FORCE Outboards

service bulletin

No. 93-7

40 - 120 H.P. Erratic Tachometer with Thunderbolt Ignition

a - Rectifier/regulator P/N 817411

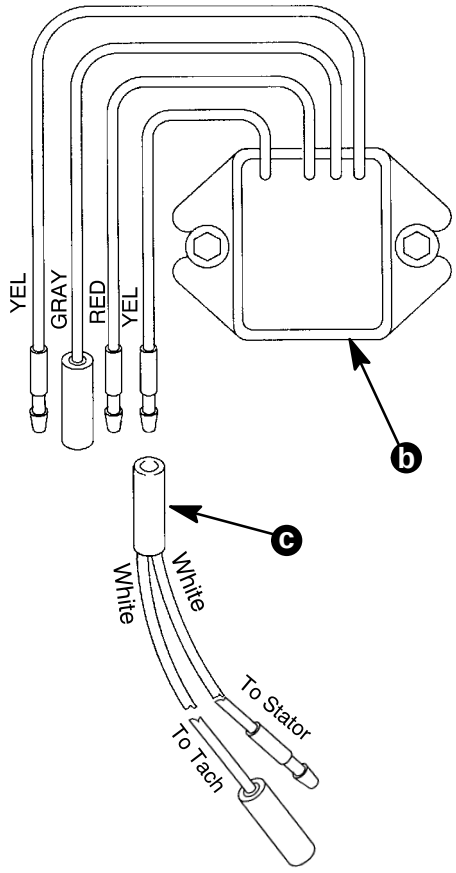
Several brands of tachometers have been found to read erratic with the rectifier/regulator (a) & (b) pictured below.

To correct this condition the tachometer lead must be connected to the Yellow rectifier/regulator lead that does not have continuity to the Gray rectifier/regulator lead. Test as follows to determine which Yellow lead to use:

1. Disconnect battery and all rectifier/regulator leads.
2. Using an ohm meter (RX1) test for continuity between each Yellow rectifier lead and Gray rectifier lead.
3. Connect the tachometer to the Yellow rectifier lead that does not have continuity to the Gray rectifier lead.

Order Adaptor Harness Kit (c) P/N 84-11149A12 for the bullet style rectifier/regulator (b) pictured below.
